Access Compliance Report Public Rights-of-Way (Curb Ramps)

Intersection ID: 21209Main Street: GALLERIA_BVCross Street: SARDIS_RD_NORTHLocation:SEADA ID: B6FC80582E8CRamp Type: ParaInitial Pass/Fail: FailOverall Compliance: NoSeverity Score:35

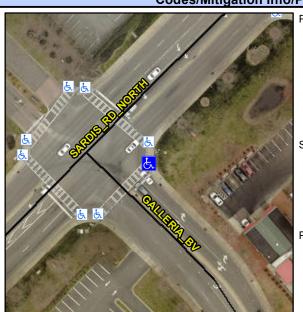
LT RP < 5%

R304.5.1, R304.5.3, R304.3.2

Field Measurements/Component Compliance					
Compliance Description		Data	Compliance Description		Data
N/A	Ramp Length LT (in)	60.0	N/A	Ramp Length RT (in)	67.0
No	Ramp Width LT (in)	37.0	No	Ramp Width RT (in)	36.0
Yes	Ramp Slope LT (%)	2.8	No	Ramp Slope RT (%)	12.0
No	Ramp XSlope LT (%)	2.8	No	Ramp XSlope RT (%)	3.2
N/A	Landing Length (in)	N/A	N/A	DWS Provided?	N/A
N/A	Landing Width (in)	N/A	N/A	DWS Contrast?	N/A
N/A	Landing Slope (%)	N/A	N/A	DWS Length (in)	N/A
N/A	Landing X Slope (%)	N/A	N/A	DWS Full Width?	N/A
N/A	Landing Curb? (Y/N)	N/A	N/A	DWS Offset (in)	N/A
N/A	Shared Landing?	N/A			
N/A	Gutter Ponding?	N/A	N/A	Gutter Slope (%)	N/A
N/A	Gutter Lip Ht (in)	N/A	N/A	Gutter X Slope (%)	N/A
N/A	Painted X Walk1?	Yes	N/A	Painted X Walk2?	N/A
	X Walk 1 Direction	To SW		X Walk 2 Direction	N/A
N/A	X Walk 1 Width (in)	92.0	N/A	X Walk 2 Width (in)	N/A
	X Walk 1 Slope (%)	2.2		X Walk 2 Slope (%)	N/A
	X Walk 1 X Slope (%)	1.6		X Walk 2 X Slope (%)	N/A

Remove & Replace Entire Ramp.
